**RE: Subgrade Inspection for Lot # 39 Hawthorne Ridge – 1528 SW Sugar Tree Dr
Lee's Summit, MO 64082 – Permit # PRRES20201526**

On June 23, 2020, a special inspection was performed by Residential Engineering Services, LLC (R.E.S.) at the above referenced property. The purpose of this inspection was to determine structural adequacy of the existing soil for construction of concrete foundation.

SPREAD FOOTING
DETAIL
N.T.S.

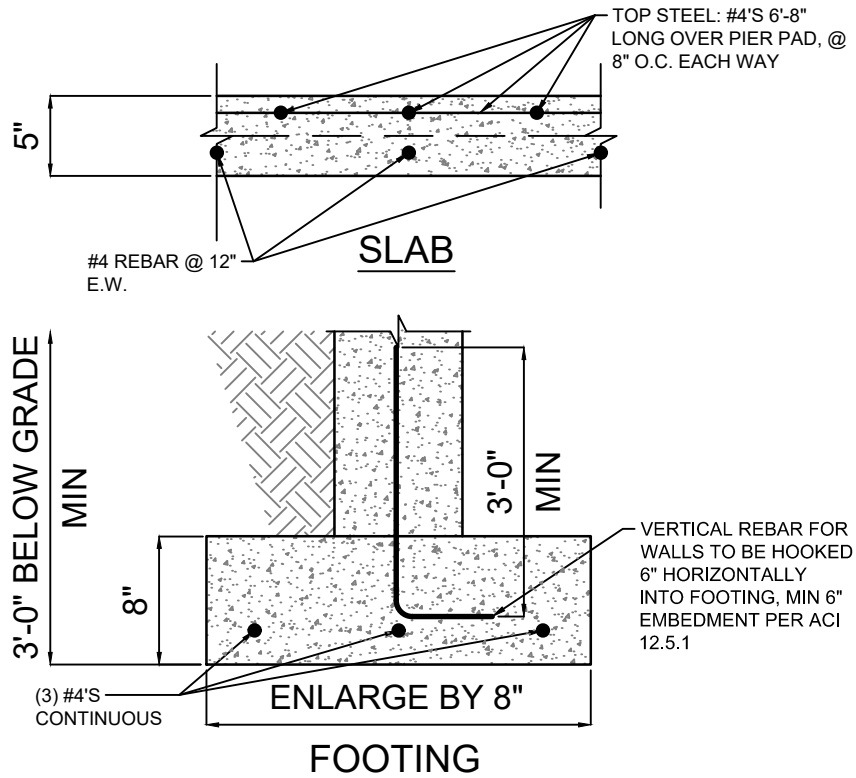
- The soils observed at footing elevation were silty clay; light brown with isolated areas of dark soils; high plasticity and slightly moist.
- Probes indicated that the soils do not have sufficient bearing capacity for the loads applied by foundation per permit plans.

- RES recommends that the footings be enlarged to 24"x8" with three (3) #4 rebar continuous (see attached specifications)
- Basement and garage pier pads shall be enlarged a minimum of 6" each way (i.e existing 30"x30" shall be enlarged to 36"x36", etc.) (see attached specifications)
